**HOLDOVER**  
*REVISED*  
**BUD MATHIS SUBDIVISION**

The purpose of this application is to create a ten-lot subdivision from two metes and bounds parcels.

APPLICATION NUMBER 17 DATE June 19, 2003

## LOCATOR MAP

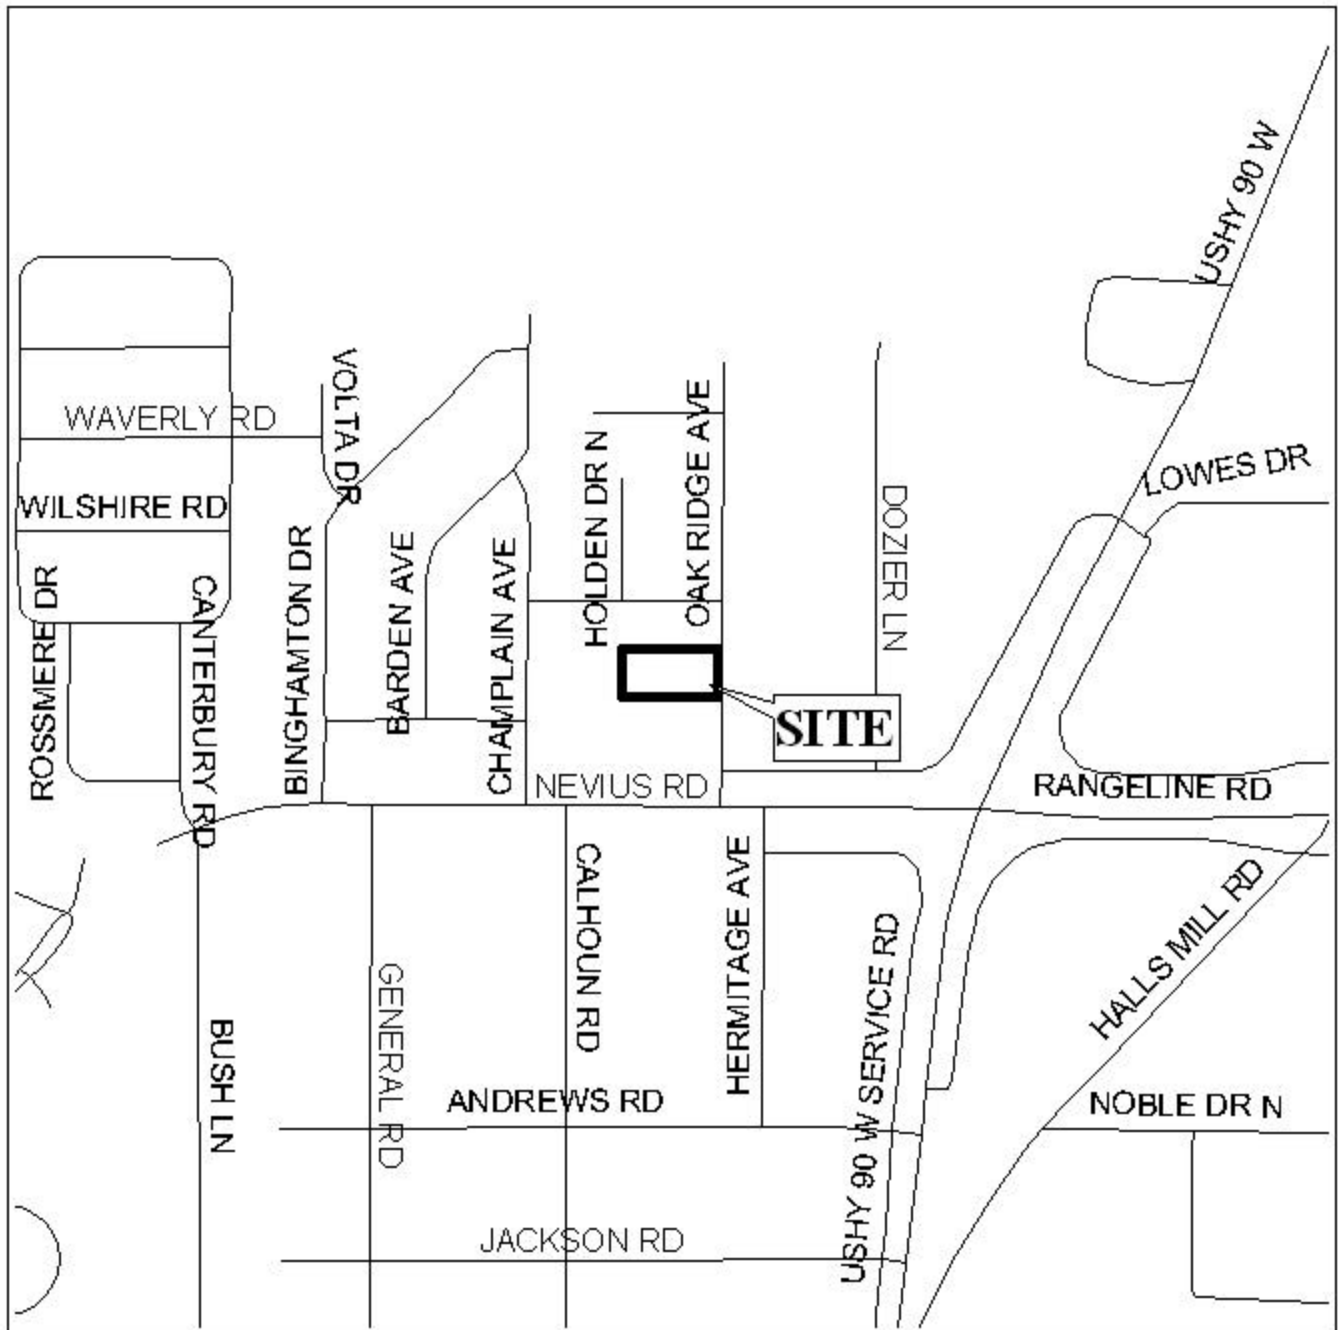
As illustrated on the Vicinity Map, it seems that two parcels to the west of the proposed subdivision were deeded off via a metes and bounds description and should be included in the subdivision. Furthermore, these parcels appear to be land-locked.

**DETAIL SITE PLAN**

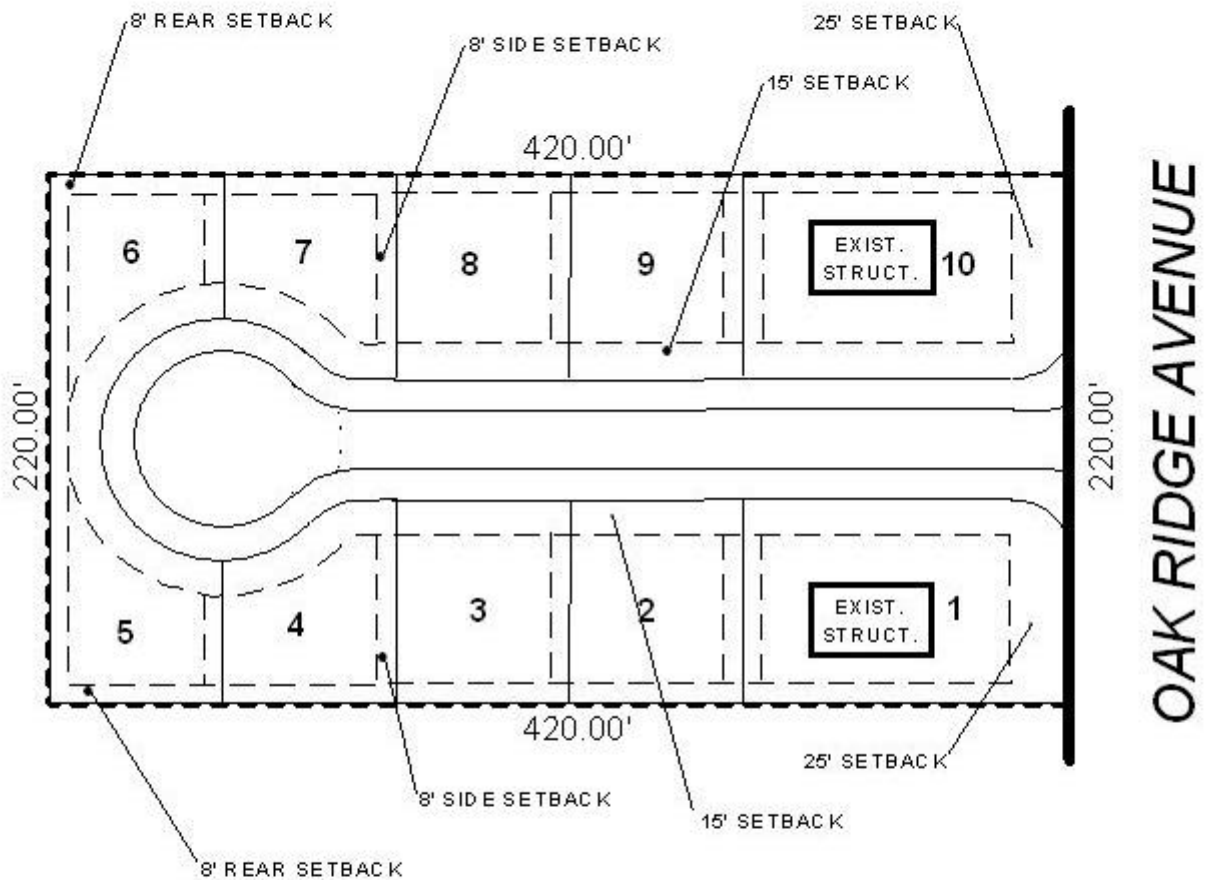
In order to provide adequate traffic management, Lots 1 & 10 should be denied direct access to Oak Ridge Avenue. Also, the minimum twenty-five foot radii should be illustrated along Oak Ridge Avenue for the proposed roadway.

The typical lot size as illustrated on the preliminary plat does not meet the minimum lot size as required by the Subdivision Regulations. Additionally, the subdivision as proposed does not fall under the Innovative Design Section of the Subdivision Regulations, which allows reduced lot widths and lot sizes, nor does the overall development maintain the density standards of the Subdivision Regulations (7,200 square foot per lot).

*The applicant submitted a revised plan further reducing the overall area from approximately 69,224 square feet to 63,306 square feet. The overall area excluding streets, does not meet the minimum lot size (7,200 square feet) as required by the Subdivision Regulations. Furthermore, no documentation was submitted to illustrate that the subdivision will consist of innovative design elements as outlined in Section VIII.C. of the Subdivision Regulations.*

*Based upon the preceding, this application is recommended for denial for the following reason:  
1) the plat contains lots that would not meet the minimum lot area requirements of the Subdivision Regulations.*
